Government of the District of Columbia

Department of Transportation

MEMORANDUM

SUBJECT: ZC Case No. 25-17 – Living Classrooms Design Review (Yards Park Parcel P3)

Figure 1 | Site Plan

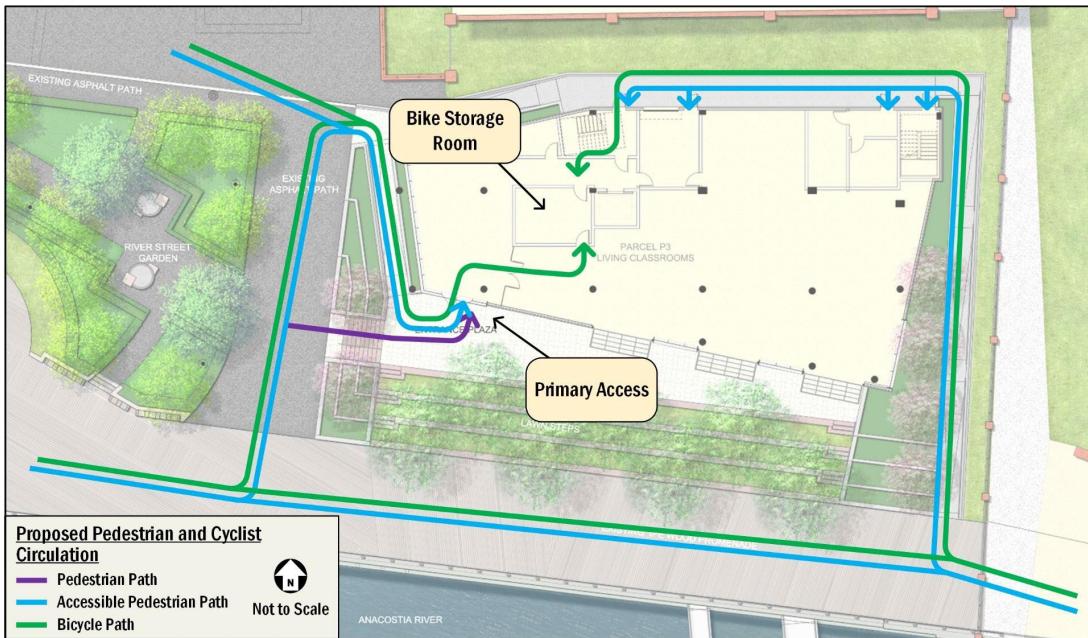
Pedestrian and bicycle access to the main entrance along the south side of the building is on the Anacostia Riverwalk Trail with secondary entrances along the north side of the building. All pedestrian access is from stairs and ramps out of public space from the Anacostia Riverwalk and Yards Park as shown in Figure 1 with indirect access via the nearby 5th Street SE. Vehicular access to the site will be provided via the planned roadways of River and 5th Streets SE; however, until this portion of the Southeast Federal Center (SEFC) Master Plan is implemented, the closest vehicular access is via 4th and

Water Streets SE. No vehicle parking is proposed or required on-site, and as such, no new curb cuts to a public street are proposed or necessary.

Figure 2 | Future Loading Access Options

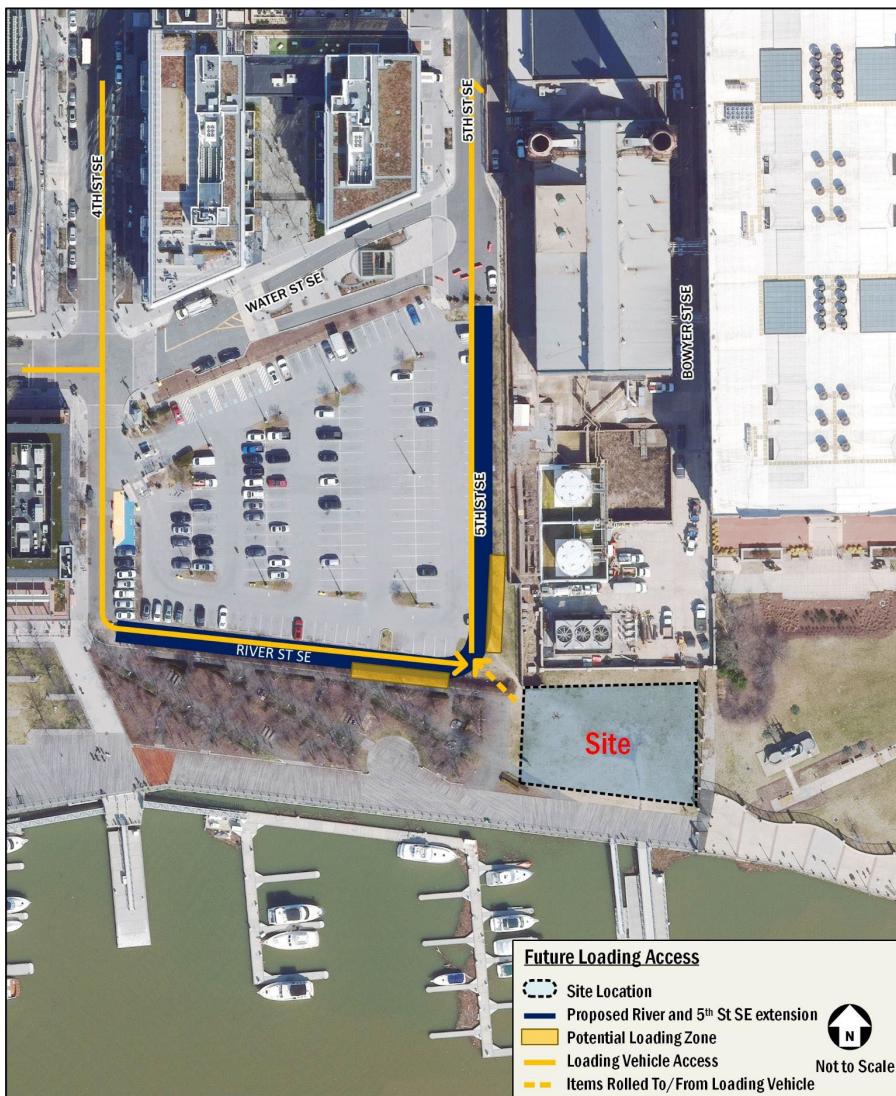
Per Title 11 of *DCMR*, Subtitle C § 901.1, all proposed uses fall below their respective minimum square footage requirements for loading facilities. Therefore, no on-site loading berths or delivery spaces are required or proposed. Nevertheless, loading operations are expected to occur close to the site along proposed private roadways that will be built as part of the Parcel Q redevelopment, as stated in the SEFC Master Plan. As the timeline for the redevelopment of Parcel Q and the adjacent roadways is unknown at this time, the Applicant has prepared both future loading access options shown in Figure 2 as well as potential interim loading access options shown in Figure 3 and listed below:

1. Loading occurs as close as possible to the site, with items rolled to and from the southeast corner of the Parcel Q surface lot. Loading vehicles accessing the Parcel Q surface lot requires partnership with Brookfield.
2. Loading occurs at the corner of Water Street SE, which is currently blocked off by temporary water-filled barriers. Items are rolled through the Parcel Q surface lot.
3. Loading occurs within the layby on the south side of Water Street SE, with items rolled through the Parcel Q surface lot.
4. Loading occurs at the dead end of 4th Street SE, with items rolled along the paved path through Yards Park.

If any interim or future loading access plans propose utilizing a curbside loading zone along a public street, the Applicant must submit a detailed curbside management and signage plan to CMD and coordinate with PSD to draft a LMP as a condition of public space permit approval.

Figure 6 | Existing Pedestrian Network

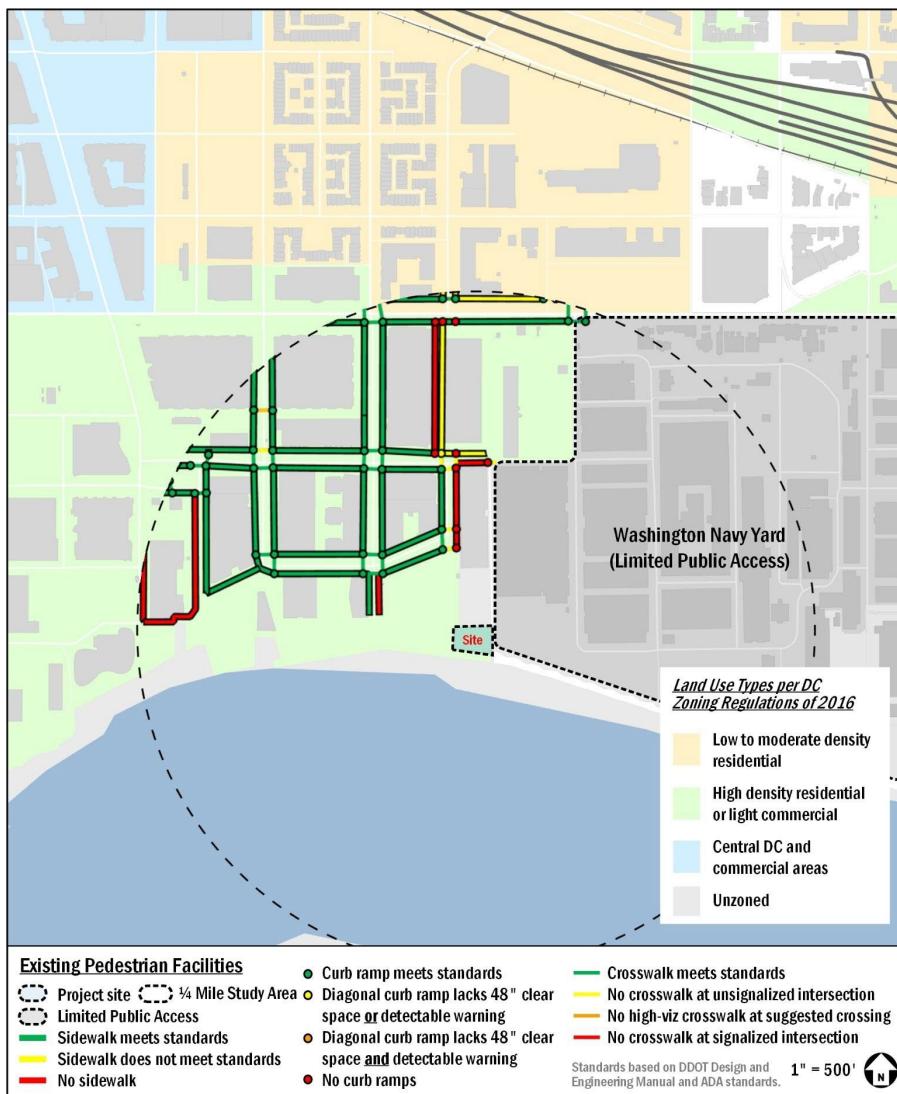
The District is committed to enhancing pedestrian accessibility by ensuring consistent investment in pedestrian infrastructure on the part of both the public and private sectors. DDOT expects new developments to serve the needs of all trips they generate, including pedestrian trips. Walking is expected to be an important mode of transportation for this development. The Transportation Statement's inventory of existing pedestrian infrastructure, as shown in Figure 6 below, demonstrates that most sidewalks in the vicinity of the site are constructed with appropriate widths and include accessible curb ramps. While there are several missing or substandard facilities in the broader area, DDOT expects the future Parcel Q redevelopment to construct pedestrian facilities along the planned private roadways as shown in Figure 7, which when coupled with the Anacostia Riverwalk Trail along the site's southern frontage as shown in Figure 8, will provide for an adequate pedestrian network along major walking routes from the site to schools, attractions, and the Metrorail station.
